## **TOWNSHIP OF LOWER MERION**

### **BUILDING & PLANNING COMMITTEE**

**WEDNESDAY, FEBRUARY 11, 2026  
6:50 PM (Approximately)**

ITEM: **PRELIMINARY LAND DEVELOPMENT PLAN - 1400 WAVERLY ROAD, (WAVERLY HEIGHTS) GLADWYNE, WARD 2, LD# 3929PP**

### 2. Pedestrian Comfort & Usability

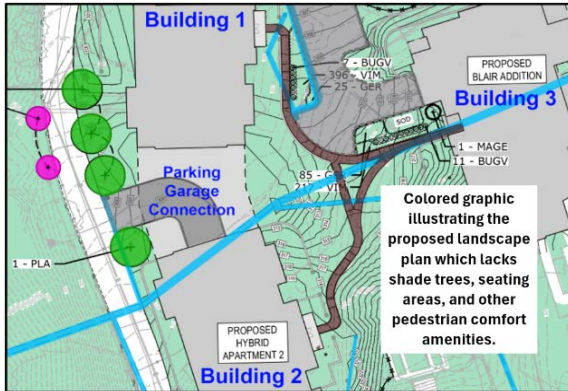
The applicant has proposed a new pedestrian path network connecting buildings 1, 2, and 3 to improve connectivity for residents, staff and visitors. Staff recommends that pedestrian comfort and usability also be enhanced through the incorporation of shade trees, intermittent seating, and trash receptacles along the new path network, as none are currently proposed on the applicant's landscape plans. These features would create shaded rest areas, encourage walking between buildings, and support a more pedestrian-friendly environment as well as attracting wildlife for viewing. Additional landscaping within the triangular area formed by the pedestrian path network is encouraged to soften hardscape elements, enhance visual interest, reduce future stormwater runoff across the sidewalk, and contribute to a cohesive and inviting open space system internal to the site.

- o Staff has included a condition of approval which states, COA #21 The applicant shall consider providing shade trees and intermittent seating, such as benches, located along the new pedestrian path network connecting Buildings 1, 2, and 3 to enhance pedestrian comfort and provide shade and rest areas.

### 3. Landscape Design & Building Massing

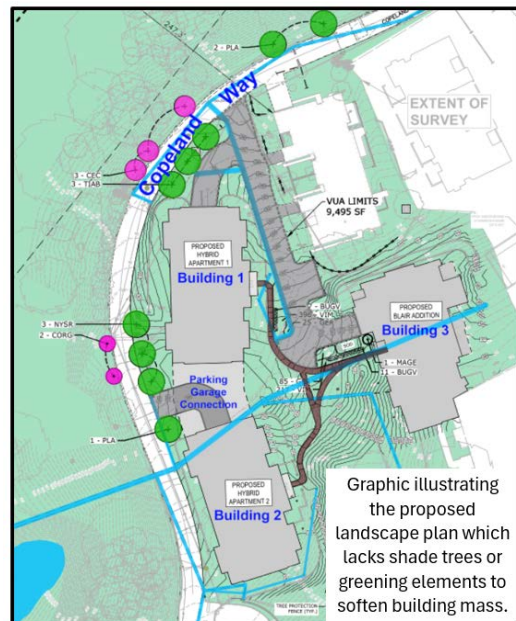
The applicant's landscape plans primarily address the visual connection along the private drive identified as Copeland Way and does not provide new canopy trees, understory trees, or columnar trees within the interior of the site or adjacent to the proposed buildings. As a result, the proposed landscaping does not adequately address the scale and massing of the building façades. The inclusion of trees adjacent to the proposed building façades will help reduce the perceived massing of the buildings and provide attractive green views from apartment interiors. This approach improves the overall aesthetic quality of the development while supporting resident well-being by strengthening the visual connection between interior living spaces and the surrounding landscape. Collectively, these measures are consistent with the Township's planning objectives and Waverly Heights' ongoing environmental stewardship.

- o Staff has included a condition of approval which states, COA #23 The applicant is encouraged to provide columnar or understory trees adjacent to the proposed building façades to soften the building massing and provide green views from apartment interiors.
